L-MT-04-014  
10 CFR 50.12

Monticello Nuclear Generating Plant  
Docket 50-263  
License No. DPR-22

Response To Request For Additional Information Related to the Fire Protection  
Exemption Request for the Torus Compartment (TAC No. MC0751)

Figure 1 (Rev. 1)

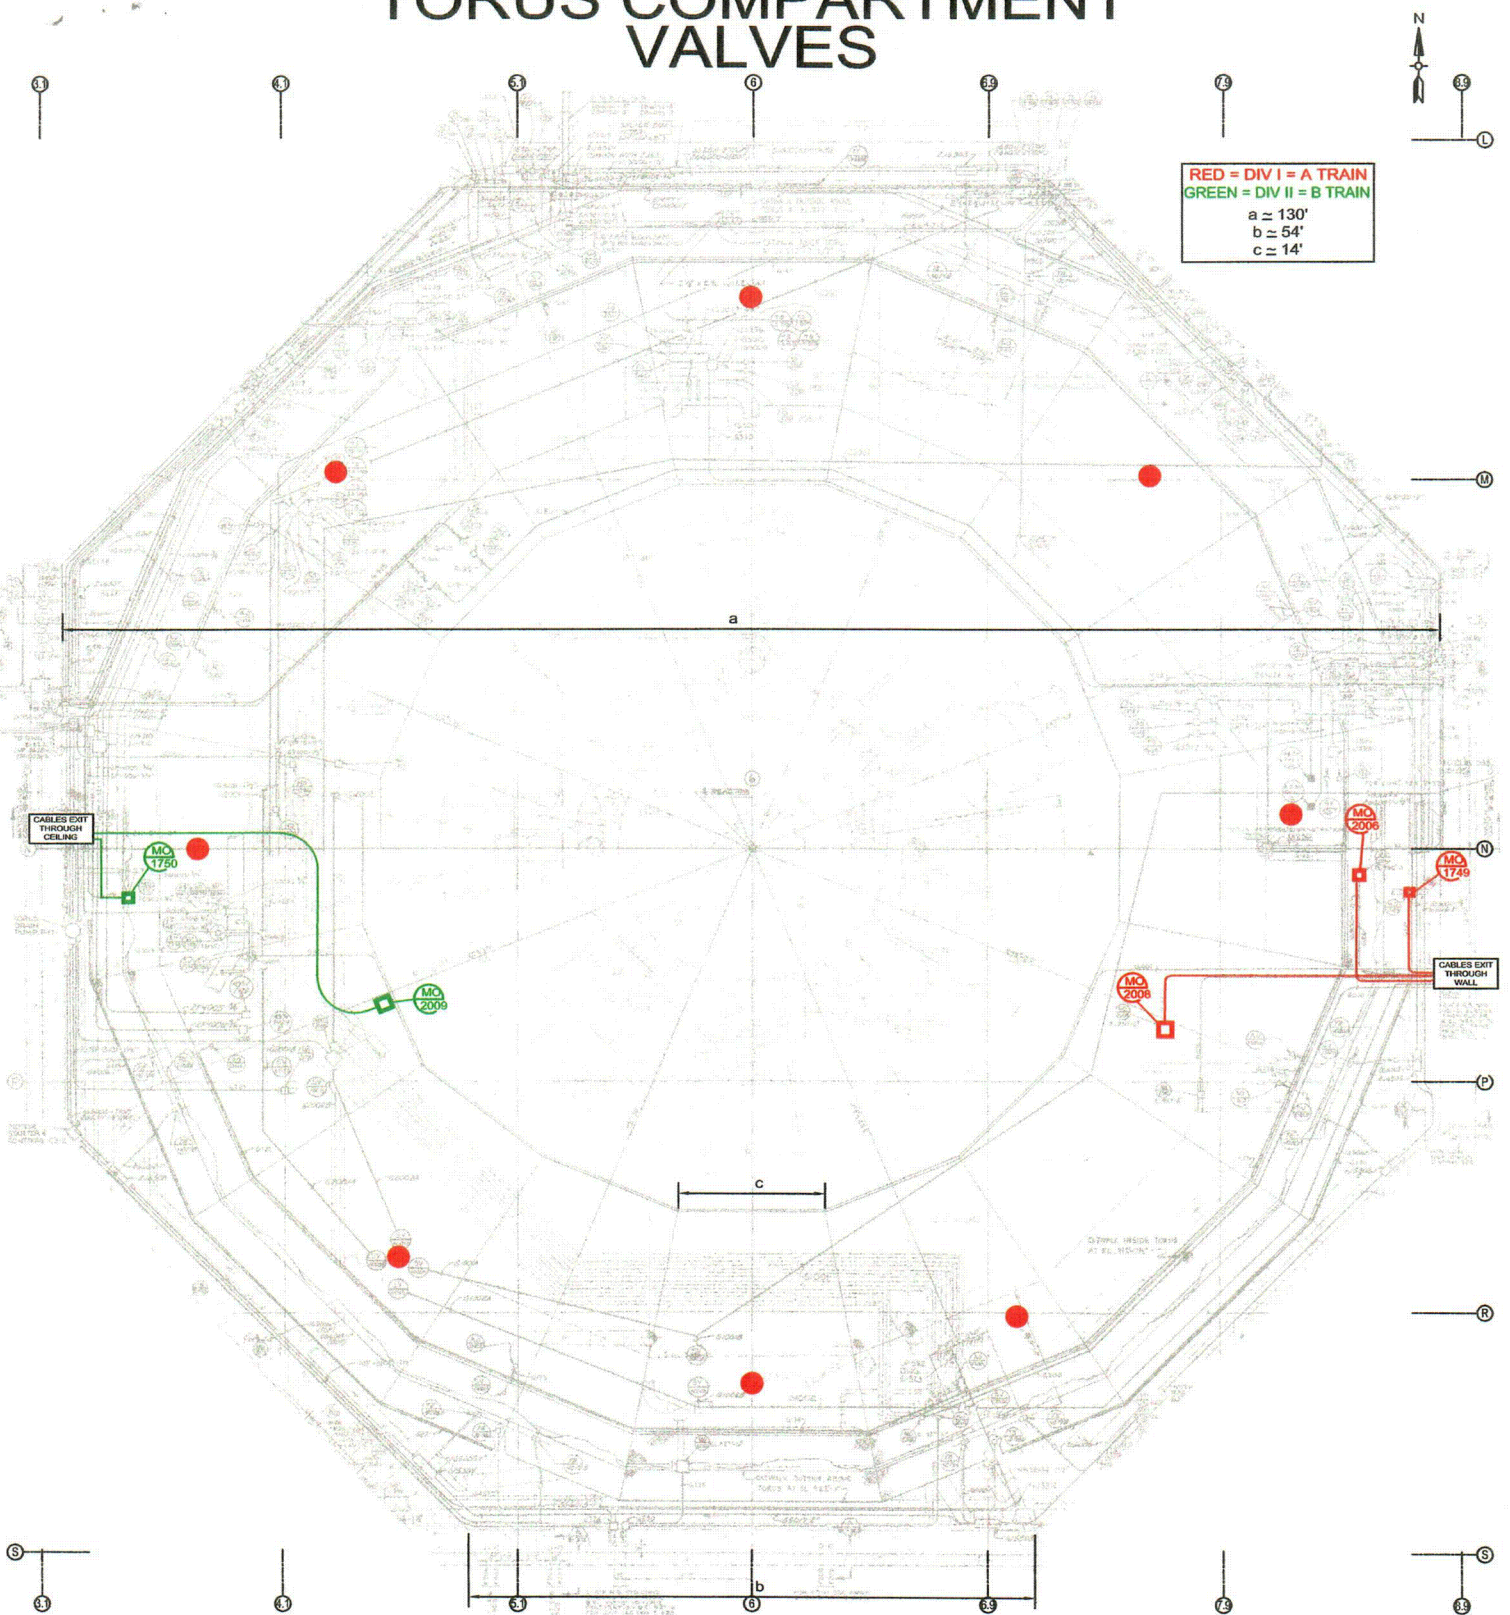
*Division 1 level transmitter LT7338A and its cable are shown on Figure 2 of Nuclear Management Company, LLC's (NMC's), letter of September 15, 2003. A notation on Figure 1 in NMC's letter shows where the cable for LT7338A exits through the ceiling. The cable does not appear to extend to where the penetration is located. What is the correct depiction?*

The correct depiction of the cable associated with LT-7338A, indicates that the conduit extends to the penetration. Therefore a revision to the Figure 1 was required. However, upon review NMC thought additional clarity was still required.

Therefore, information related to instrumentation in the Torus area has been eliminated from Figure 1 and transferred to Figure 2 as appropriate. All information associated with instrumentation is now detailed on Figure 2. Depicting instrumentation on a single figure serves to clarify the component and cable arrangements within the Torus Compartment.

Revised figures are provided in Enclosure 2. Additional changes to the figures are identified in the NMC Response to NRC Request #2, immediately below, and in the Additional Information section provided at the end of this Enclosure. The revised figures supercede the figures provided in Reference 1.

Figure 2 (Rev. 1)

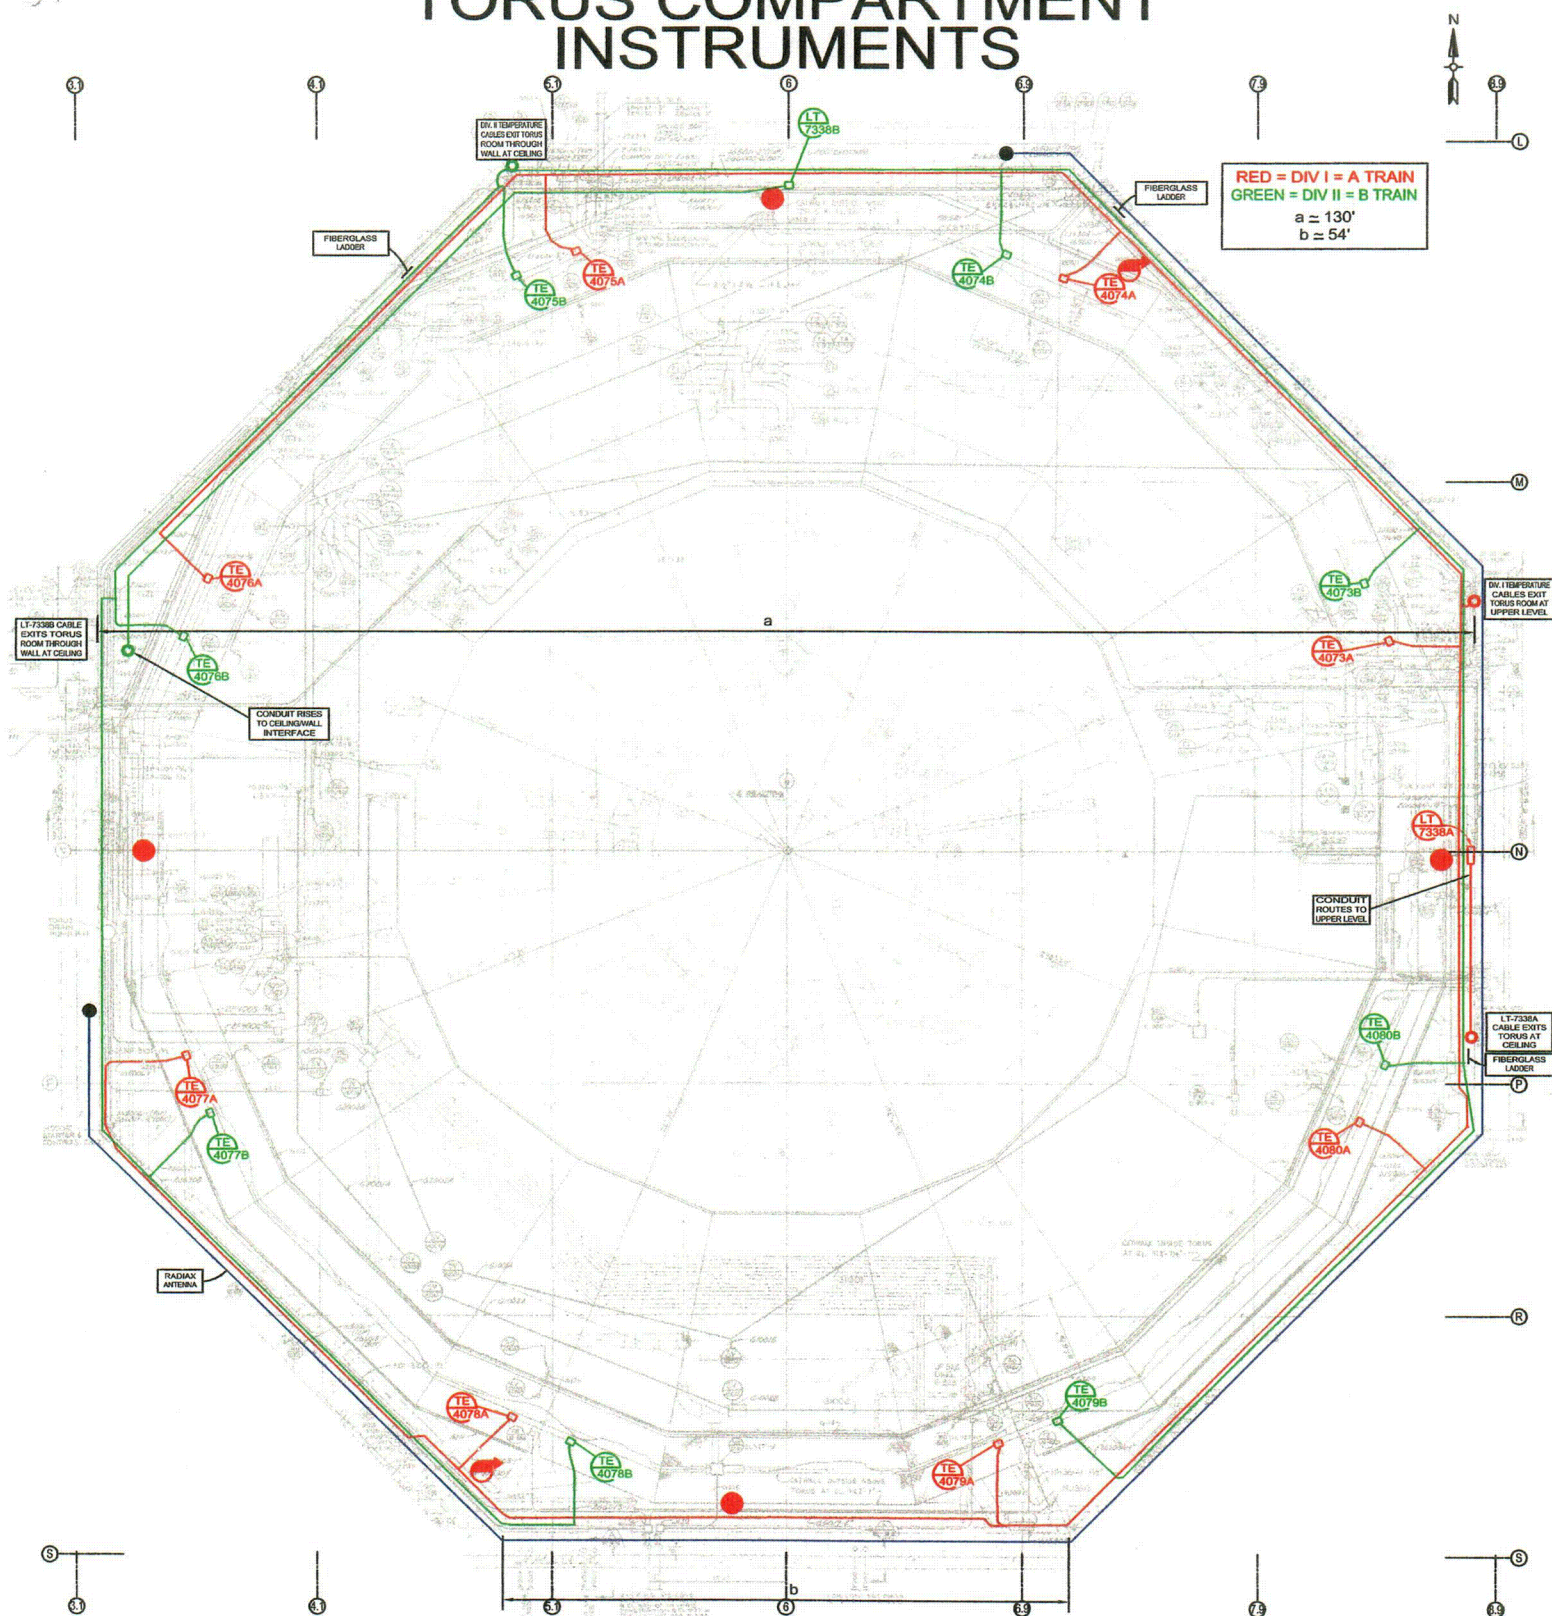
*Figure 2 shows that Division 2 level transmitter LT7338B is connecting to the same conduit system downstream of Division 2 temperature element TE4075B, while Division 2 temperature elements TE4073B and TE4074B are shown as exiting the torus room at column lines L and 5.1. Is this an accurate representation? Note that the opening statement in Attachment 1, Section B, "Background," of NMC's letter of September 15, 2003, discusses the incorrect depiction of the Division II suppression pool level transmitter in your submittal of October 28, 1982.*

No, this was an inaccurate representation. Figure 2 has been revised to reflect the conduit route of LT-7338B, independent of other Division II conduits, to agree with the configuration in the plant. Also, the exit point of the transmitter cable has been shown.

Previously, the divisional conduits were shown in "one-line" fashion in order to simplify the information on Figure 2. In addition, not all Division II temperature element conduits were shown connected to the exit point at approximate coordinates 5.1/ L in Reference 1, Figure 2.

A revised Figure 2 is provided in Enclosure 2.

In the course of revising Figure 2, additional corrections and clarifications were made. First, the cables/conduits from TE-4079B and TE-4080B were removed from the conduit system associated with TE-4078B, TE-4077B, and TE-4076B. The revised route is via the conduit system associated with TE-4073B and TE-4074B. This change has no bearing on the Reference 1 discussions or the response to NRC Request # 3 above.

Second, the exit point of the Division I suppression pool temperature monitoring cables/conduits was moved 16 ft north of the "N" line as opposed to at the "N" line. This change modifies statements made in Attachment 1, Section C.4.c of Reference 1 as described below.
